Technical Service Information

MAZDA/FORD GF4A-EL NO 4TH GEAR, AFTER REBUILD

Figure 1

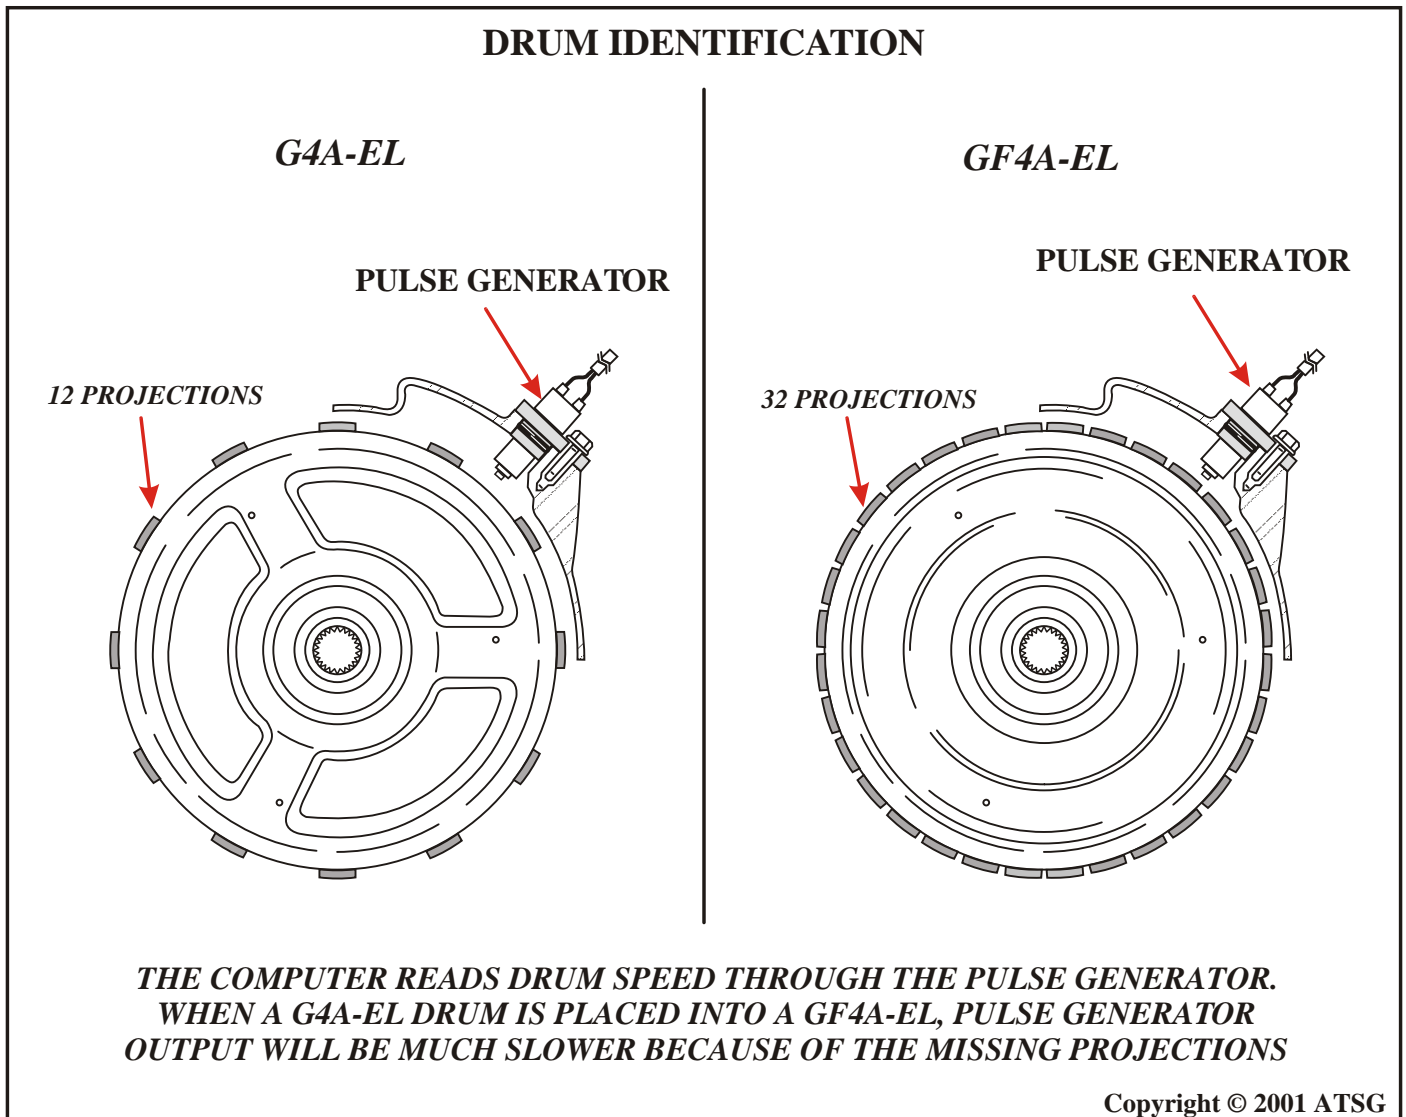
COMPLAINT: Vehicles equipped with *GF4A-EL* transaxles may exhibit a NO 4th gear condition after overhaul.

CAUSE: The cause may be, a 12 projection *G4A-EL* Reverse, Forward and Coast drum was installed into a *GF4A-EL* application, which requires a 32 projection drum. When this happens the computer will not command 4th gear because of the missing projections which results in slower drum speed.

CORRECTION: To correct this condition, refer to Figure 1 for drum identification and ensure that the 32 projection drum is installed on all *GF4A-EL* applications.
